8 May 2025

**50 Condoover Street Balgowlah
Modification under Section 4.55(2) to DA2023/0541 to alter the approved
development for 2 dwelling houses**

Figure 1 – excerpt of the approved driveway layout plan CV-100 showing approved Lot 1

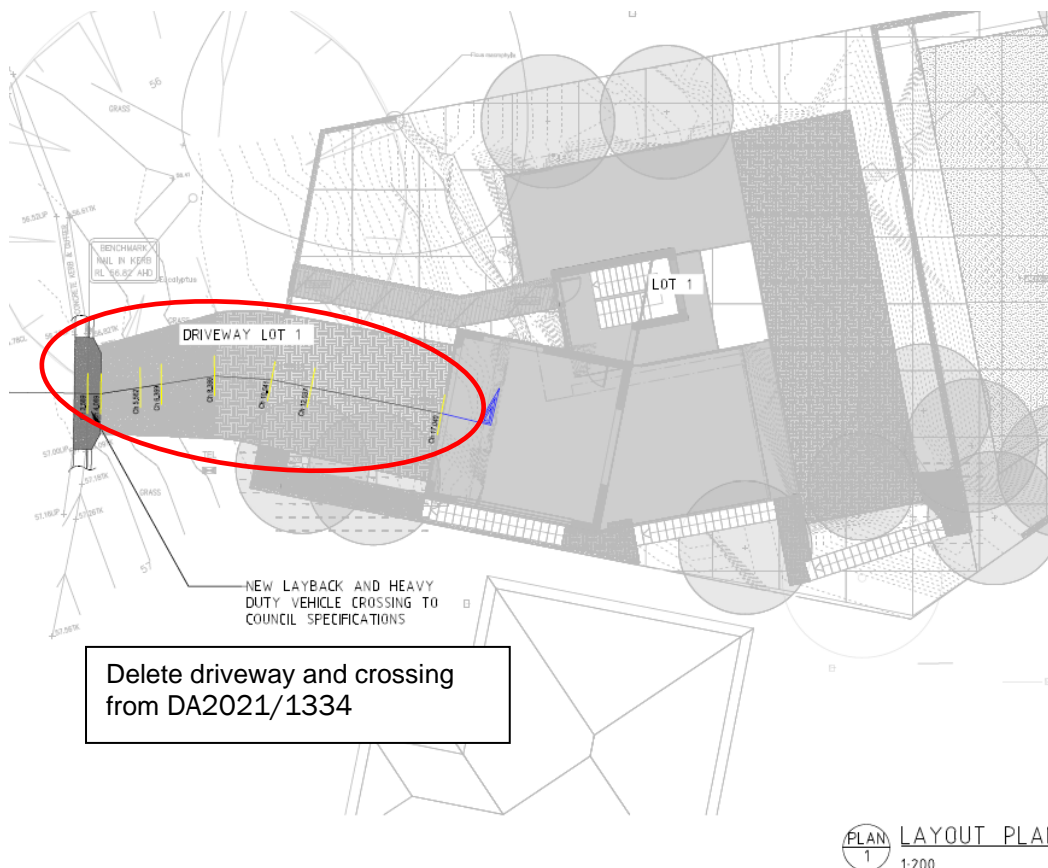
Two driveways [and their kerb crossings] to each approved lot are proposed to be deleted from DA2021/1334 and incorporated in DA2023/0541.

The consent currently requires the construction of the driveways with the subdivision works however it is the landowner's intention to undertake the subdivision works and construction of the dwelling house on approved Lot 2 as an initial, 'single' phase of work. Furthermore in relation to approved lot 2 its proposed to construct the dwelling house first and the driveway after.

There is a high likelihood that the driveway will be damaged during the construction of the dwelling house. It is therefore preferred to construct the driveway after the dwelling house is constructed to minimise potential damage, the potential need for reconstruction, and the associated time delays and costs,

The construction of the driveways and kerb crossings for approved Lots 1 and 2 may be undertaken following the registration of the subdivision. However, the approved Lots cannot be sold until all subdivision works including the construction of the driveways are completed.

Conditions 10 and 14 in DA2021/1334 are replaced by conditions [to be numbered and named] in this consent meaning that vehicle driveways and vehicle crossings may be constructed following the construction of each dwelling house in accordance with this consent.
